SIGLER FAMILY DIVISION SUBDIVISION

Engineering Comments: FINAL PLAT COMMENTS (should be addressed prior to submitting the FINAL PLAT for acceptance and signature by the City Engineer):

DETAIL SITE PLAN

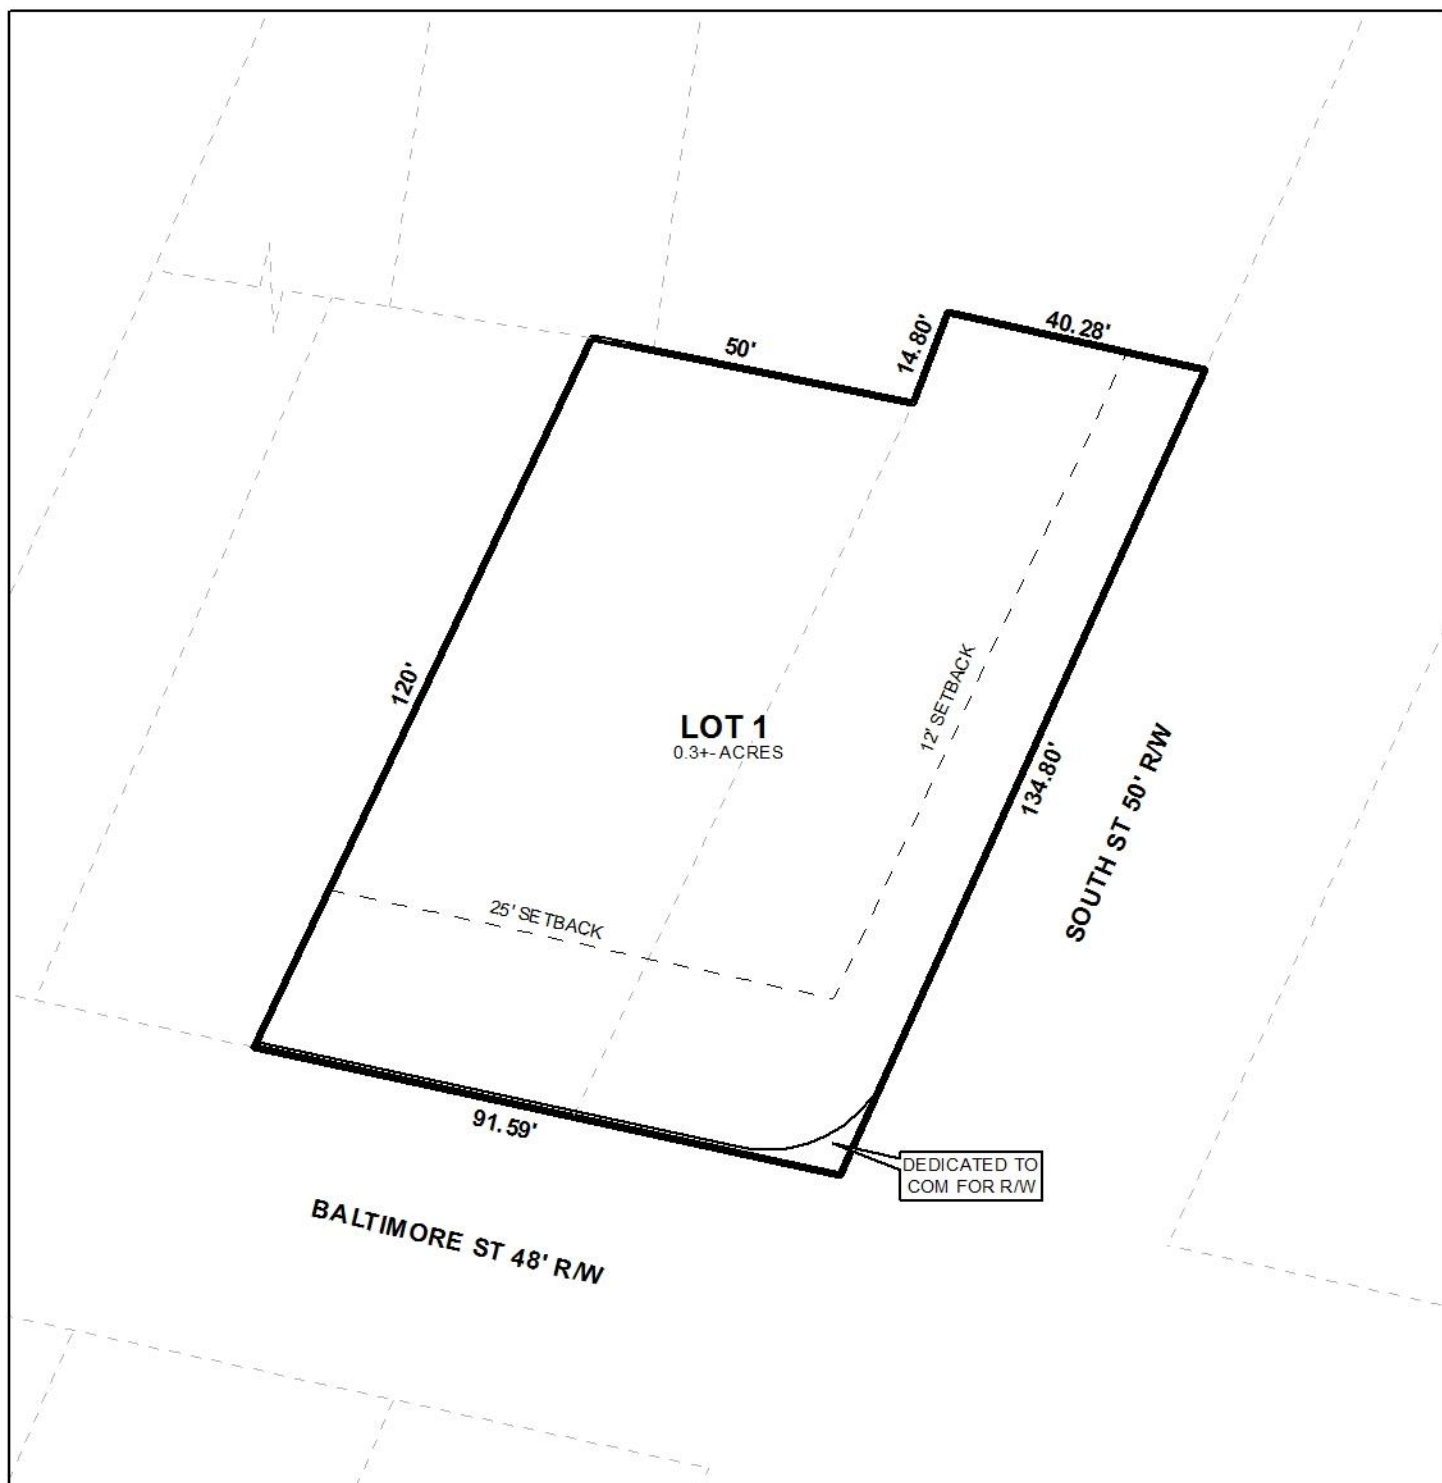
The proposed lot fronts Baltimore Street and South Scott Street; both of which are minor streets with curb and gutter. As minor streets, Baltimore Street and South Scott Street require a 50' right-of-way width. The right-of-way width of South Scott Street, as indicated on the preliminary plat, reflects compliance with minor street standards and if approved, should be retained on the Final Plat. The right-of-way width of Baltimore Street is indicated as being 48'. If approved, the Final Plat should be revised to provide dedication to provide 25' to the centerline along Baltimore Street, as shown on the preliminary plat. The preliminary plat illustrates dedication of the corner radii as per Section V.D.6. of the Subdivision Regulations. If approved, the dedications should also be illustrated on the Final Plat.

A 25-foot minimum building setback line is depicted on the preliminary plat along Baltimore Street and, if approved should be retained on the Final Plat. It should be noted that the applicant has requested a waiver of Section V.D.9. of the Subdivision regulations for the South Scott Street side setback to allow a 12' setback along South Scott Street. Section V.D.9. of the Subdivision Regulations require a 25' building setback; however, Section 64-4.D.3. of the Zoning Ordinance allows for reduced setbacks for a side street on a corner lot. If approved, the 12' minimum setback line along South Scott Street should be retained on the Final Plat.

The proposed lot exceeds the 7,200 square foot minimum lot size requirements for lots served by public water and sanitary sewer systems. The preliminary plat provides the lot sizes in acres. If approved, the lot size information should be depicted in both square feet and acres on the Final Plat.

As a means of access management, a note should be placed on the Final Plat, if approved, stating that the proposed lot is limited to one curb cut per street frontage, with any changes in the size, design and location to be approved by Traffic Engineering and conform to AASHTO standards.

- 1) Retention of the 25' minimum building setback line along Baltimore Street;

- 2) Retention of the 12' minimum building setback line along South Scott Street;
- 3) Provision of the lot size information in both square feet and in acres;

- 4) Placement of a note on the Final Plat stating that the proposed lot is limited to one curb cut per street frontage, with any changes in the size, design and location to be approved by Traffic Engineering and conform to AASHTO standards.

- 5) Dedication along Baltimore Street, as depicted in the preliminary plat;
- 6) Provision of the corner radius, as depicted on the preliminary plat;
- 7) Compliance with Engineering comments: (*FINAL PLAT COMMENTS (should be addressed prior to submitting the FINAL PLAT for acceptance and signature by the City Engineer): A. Provide all of the required information on the SUBDIVISION PLAT (i.e. signature blocks, signatures, certification statements, written legal description, required notes, legend, scale, bearings and distances) that is required by the current Alabama State Board of Licensure for Professional Engineers and Land Surveyors. B. Provide a signature block for all three (3) owners listed. C. Show and label the proposed LOT designation. D. Show and label the existing Lot 11M that is listed in the written legal description. E. Review and revise the written legal description to include a written bearing and distance for the entire north property line. F. Provide and label the monument set or found at each subdivision corner. G. Add a signature block for the Planning Commission. H. Revise the signature block for the Mobile City Planning (Dept.) to be Mobile City Planning Commission. I. Provide the Surveyor's, Owner's (notarized), Planning Commission, and Traffic Engineering signatures. J. Add a note to the SUBDIVISION PLAT stating that a Land Disturbance permit will be required for any land disturbing activity in accordance with Mobile City Code, Chapter 17, Storm Water Management and Flood Control); the City of Mobile, Alabama Flood Plain Management Plan (1984); and, the Rules For Erosion and Sedimentation Control and Storm Water Runoff Control. K. Add a note to the Plat stating that the approval of all applicable federal, state, and local agencies (including all storm water runoff, wetland and floodplain requirements) will be required prior to the issuance of a Land Disturbance permit. L. Add a note that sidewalk is required to be constructed, and/or repaired, along the frontage of each lot, or parcel, at time of new development or construction, unless a sidewalk waiver is approved. M. Provide a copy of the FINAL PLAT to the Engineering Dept. for FINAL PLAT review prior to obtaining any signatures. N. After FINAL PLAT review by the Engineering Dept. provide the red-line markup, a copy of the revised original Final Plat, and the original when submitting for City Engineer signature.);*
